**PLANNING AND ZONING COMMISSION  
STAFF REPORT**

**Planning Exception case no. PE16-01: Osborn Business Park**

**CASE DESCRIPTION:** a request for approval of an exception from standards for subdivision design of the Subdivision Ordinance (Bryan Code of Ordinances Chapter 110) which states that drainage easements shall not be considered part of the lot area for purposes of minimum lot size requirements for lots zoned Commercial District (C-3), to allow proposed new Lot 4 in Block 2 of the Osborn Business Park – Phase 2

## PROPOSED LOT 4 IN BLOCK 2:

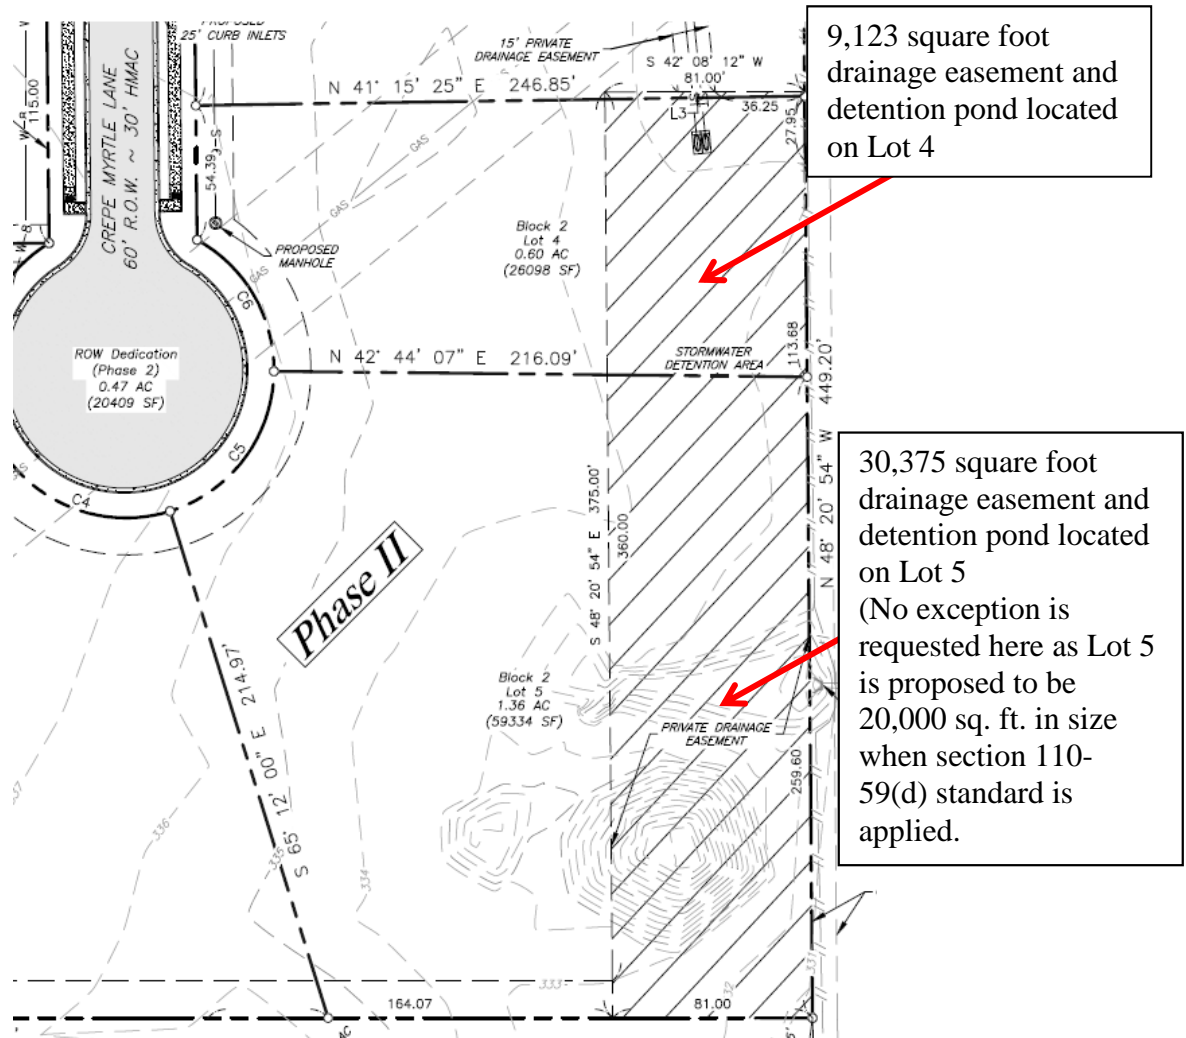
**In this circumstance, proposed Lots 4 and 5 in Block 2 of the Osborne Business Park – Phase 2 are the most reasonable lots for the proposed storm water detention area because of the elevation and flows on the land. The highest elevation of the 11.814-acre tract of land is located in the southwestern-most corner of the property (346 feet). The lowest elevation (332 feet) of the proposed business park is located at the back of proposed Lots 4 and 5 and is 14 feet lower than the highest point of the property. Therefore, the proposed location for the storm water detention pond is the most reasonable and logical location for the conveyance and detention of storm water.**

**Lot 4 is proposed to be 26,098 square feet in size, with a width of 119.18 feet and 246.28 feet of depth, exceeding the minimum lot width and depth requirements for lots in the C-3 zoning district. The subdivision of land requires an adequate drainage plan for the entire 11.814-acre tract of land. Being that Lot 4 is the most logical location for the storm water detention pond, staff believes that, in this circumstance a 15% reduction in lot area for Lot 4 will still allow sufficient room for modern commercial development.**

**Staff believes that the overall effect of allowing the 3,025 square feet of proposed storm water detention pond and drainage easement areas on proposed Lot 4 in this subdivision phase to be counted with the overall lot size will be negligible, if at all noticeable, given the properties' extraordinary lot width, depth and overall size. Granting this exception will still allow for the development of a commercial subdivision at this location.**

Staff recommends **approving** the requested exception.
